WIMMER FAMILY DIVISION SUBDIVISION

APPLICATION NUMBER 19 DATE October 7, 2004

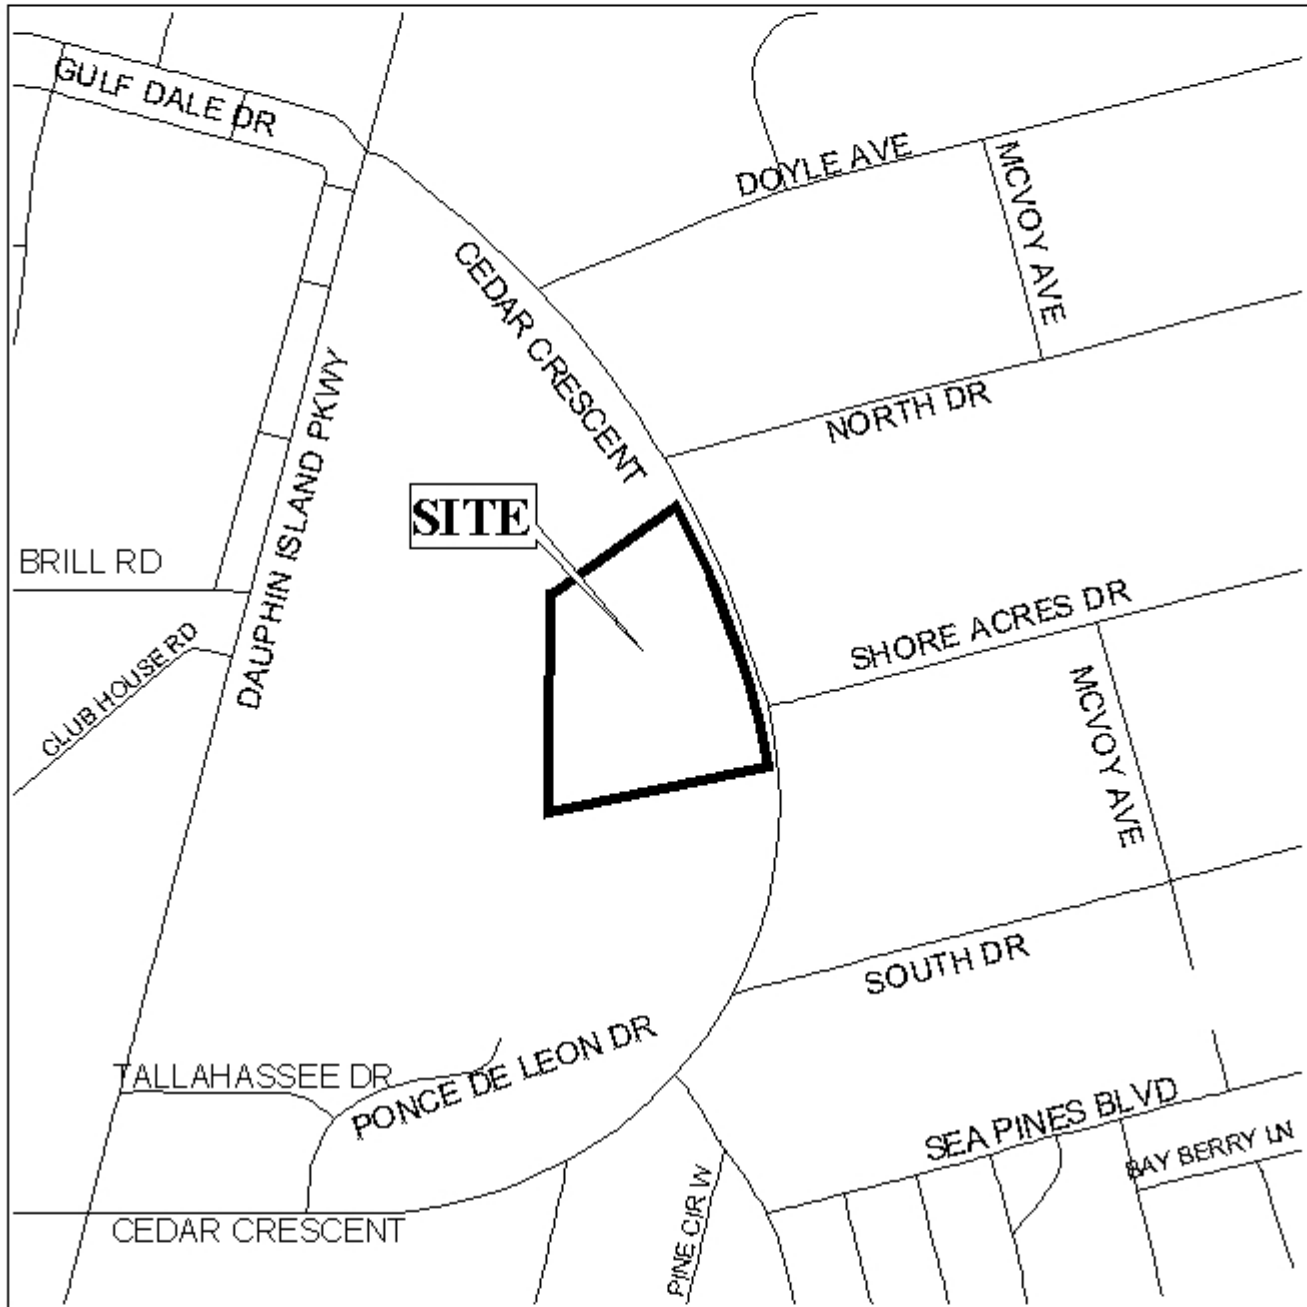
The plat illustrates the proposed 7 lot, 6.8 \pm acres subdivision which is located on the West side of Cedar Crescent Drive, 75' \pm South of the West terminus of North Drive, extending to the West terminus of Shore Acres Drive and is in City Council District 3. The subdivision is served by public water and sanitary sewer.

Lots 3 through 7 exceeds the maximum width to depth ratio as recommended by the Subdivision Regulations; therefore, a waiver of Section V.D.3., would be required. The proposed resubdivision will essentially maintain the existing width to depth ratio, thus a waiver of V.D.3. could be considered appropriate.

The existing Tank Service is a legal nonconforming use. The plot plan illustrates a proposed office. The applicant should note that building permits will be required.

With modifications and a waiver of Section V.D.3., the plat will meet the minimum requirements of the Subdivision Regulations and is recommended for Tentative Approval.
